**FEDERAL AVIATION ADMINISTRATION
AIRWORTHINESS DIRECTIVES**

**SMALL AIRPLANES, ROTORCRAFT, GLIDERS,
BALLOONS, & AIRSHIPS**

BIWEEKLY 2015-03

2014-12-11 R1 Sikorsky Aircraft Corporation: Amendment 39-18091; Docket No. FAA-2009-1088; Directorate Identifier 2008-SW-76-AD.

Figure 1 to Paragraph (f)(3)(iii)

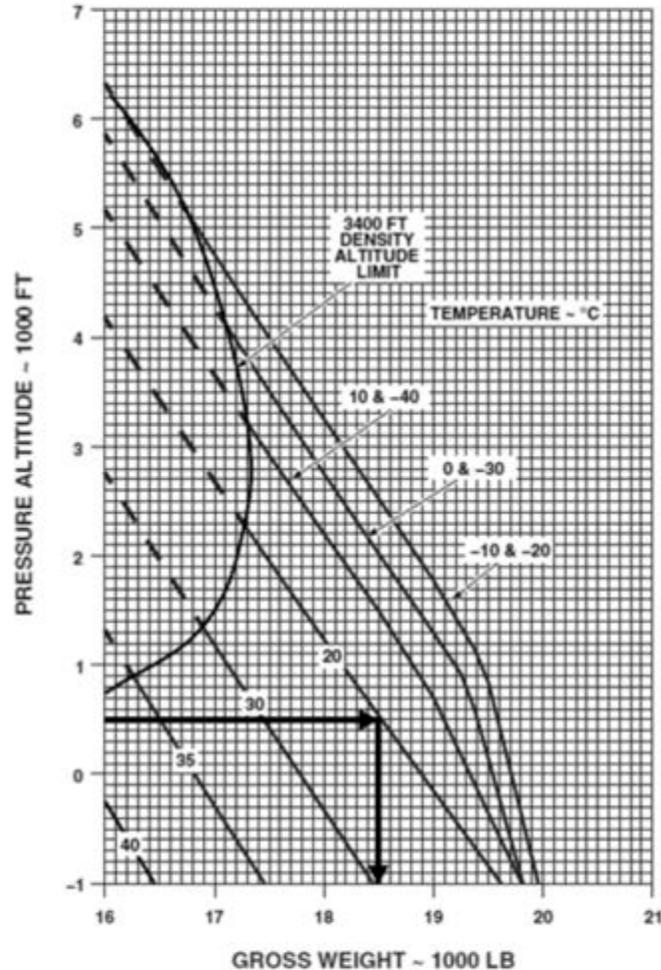
(iii) Add the following and insert Figure 1 to Paragraph (f)(3)(iii) of this AD:

" "HOIST" Maximum gross weight for Human External Cargo, which requires category 'A' performance capabilities, is limited to the gross weight determined in accordance with the following Figure 1 to Paragraph (f)(3)(iii) of this AD for your altitude and temperature with the air-conditioner, anti-ice, and bleed air turned off."

Note 1 to paragraph (f)(3)(iii) of this AD: Figure 1 to Paragraph (f)(3)(iii) of this AD becomes Figure 1-2A when inserted in the "Weight Limits" section of your RFM.
